Attachment B-4 Marysville

SITE PLAN

DATE: 1/1/10
PROJECT: MARYSVILLE PUBLIC LIBRARY
SHEET: 101

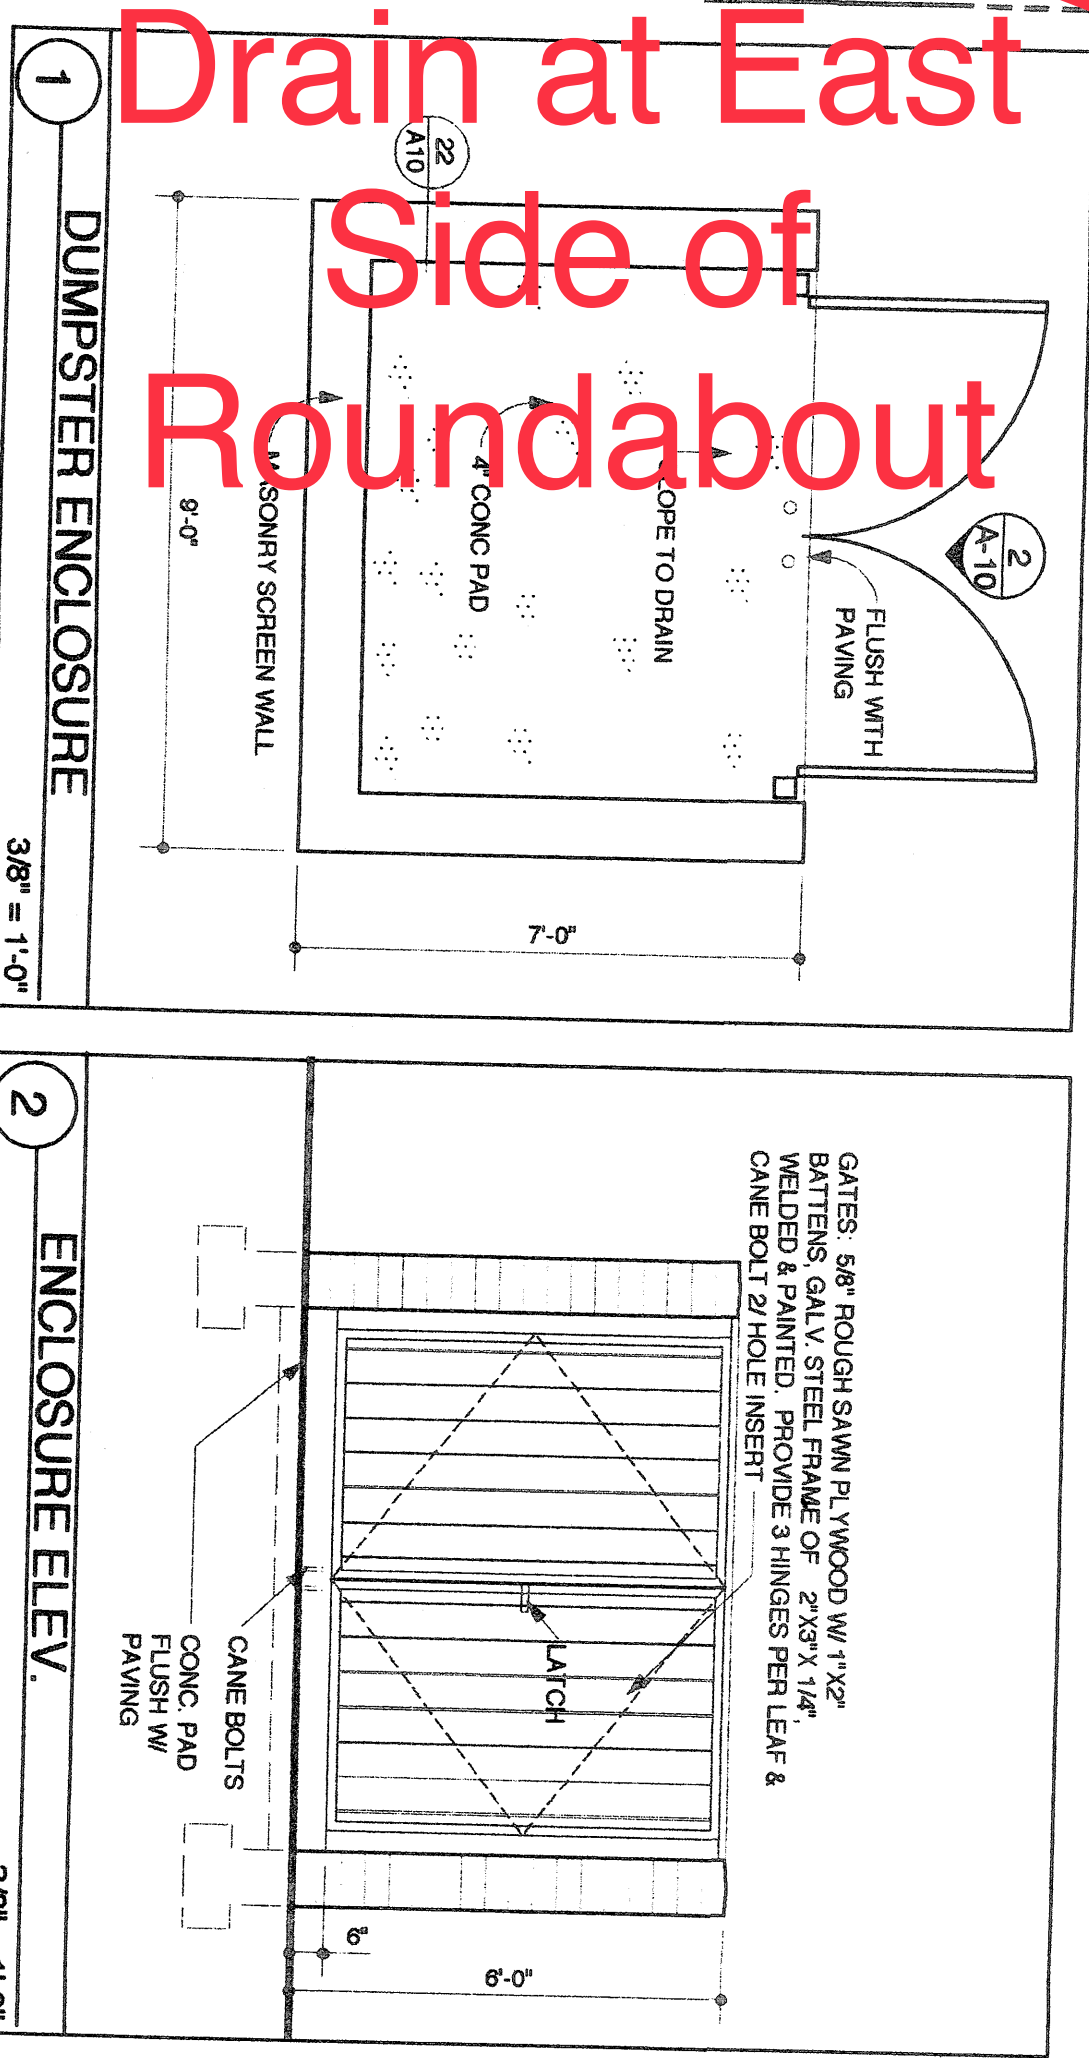
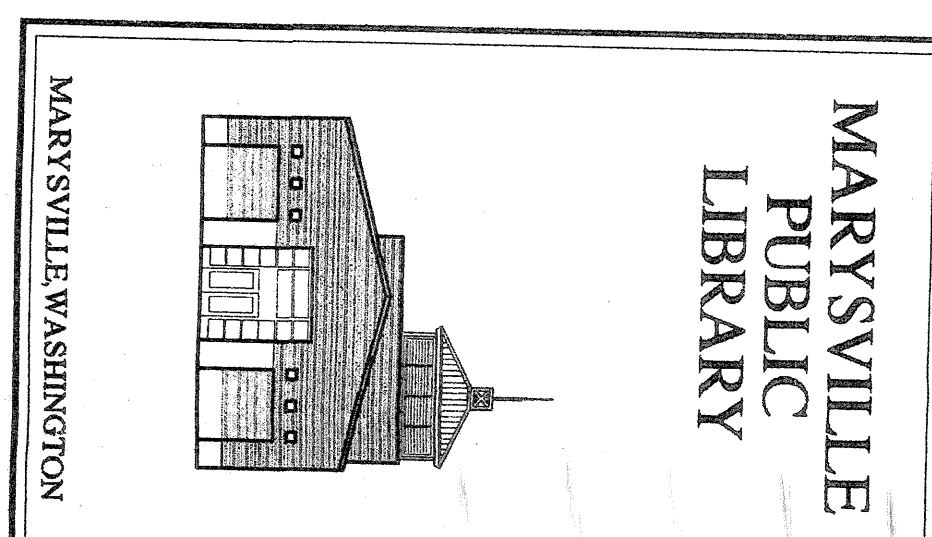
****Site needs seal-coating
additionally — all curbs need
reconditioned/repainted**

**Alternate 1
Approx.
42'L x 10'W
Repair/
Possibly form
inverted crown
for proper
drainage to
Drain at East
Side of
Roundabout**

**Alternate 2
Remove and replace
Approx 120 LF of
curbing**

**Replace asphalt 2"
back off of curbing.**

NoteTransition
From asphalt to sidewalk**
